Starbucks Cashmere

Special Exception Use
Project No. P23-188

Planning and Zoning Board Meeting
Bethany Grubbs, Planner III
April 2, 2024

Conceptual Plan

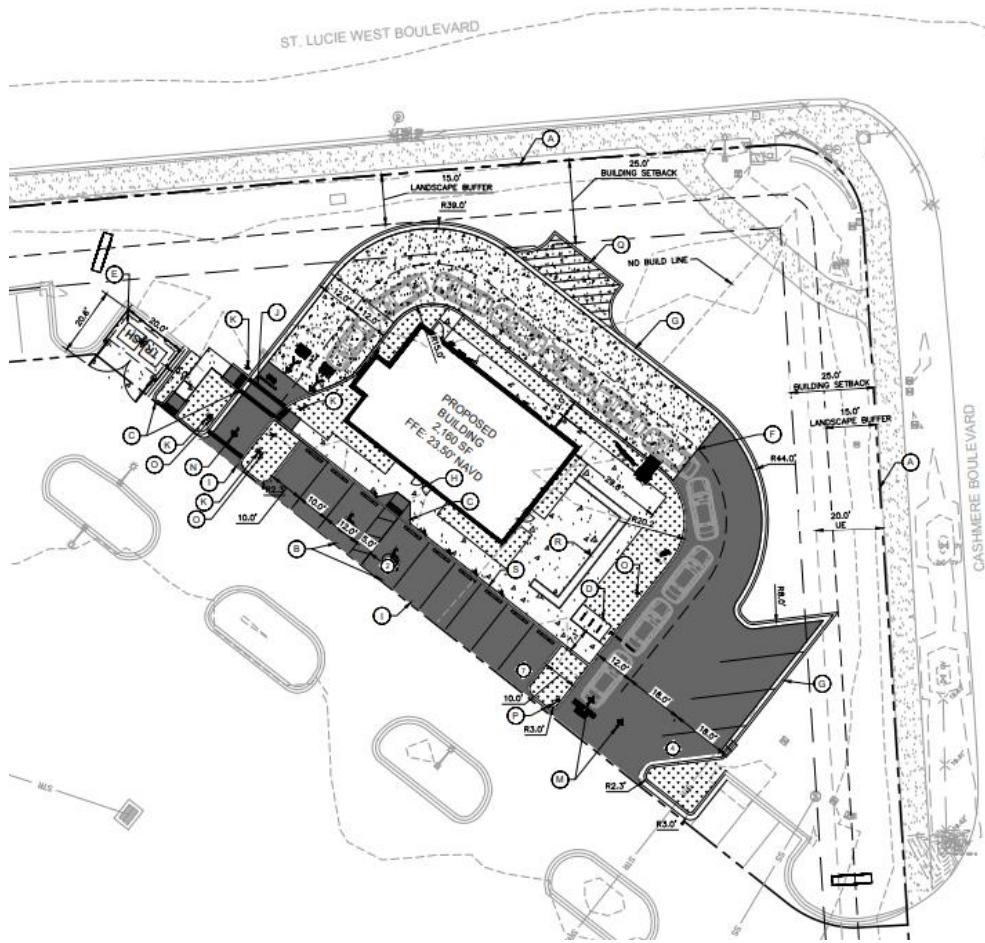
- A queueing analysis of three Starbucks restaurants located within a 10-mile radius of the proposed location was provided, which indicates a maximum queue length of eleven (11) vehicles is needed.
- No significant traffic impact is proposed based on the conceptual site plan and drive-through queueing analysis submitted.

| Evaluation of SEU CRITERIA (Section 158.260) | FINDINGS |
|--|--|
| ADEQUATE INGRESS AND EGRESS (§ 158.260 (A)) | Adequate ingress and egress shall exist with regard to automotive and pedestrian safety by means of four compliant driveways, associated crosswalks, and traffic control devices which allow for adequate internal circulation and traffic flow. |
| ADEQUATE OFF-STREET PARKING AND LOADING AREAS (§ 158.260 (B)) | The use requires 34 standard parking spaces and 2 ADA parking spaces. The conceptual site plan provides for an overall of 29 standard parking spaces and 2 ADA parking spaces. Per a recorded easement agreement, the owner of Outparcel 2 has the right to allow its tenants, customers, and employees, etc. to park on the parking areas of all other Tracts and Outparcels. There is an excess on the associated overall site plan which provides 447 parking space with 423 required; Therefore, the applicant has provided adequate parking within the proposed conceptual site plan. |
| ADEQUATE SCREENING OR BUFFERING (§§ 158.260 (D) (F)) | A 6-foot in height continuous hedge will be planted to screen the drive-through lane from view, mitigating visual impacts on St. Lucie West Boulevard. |
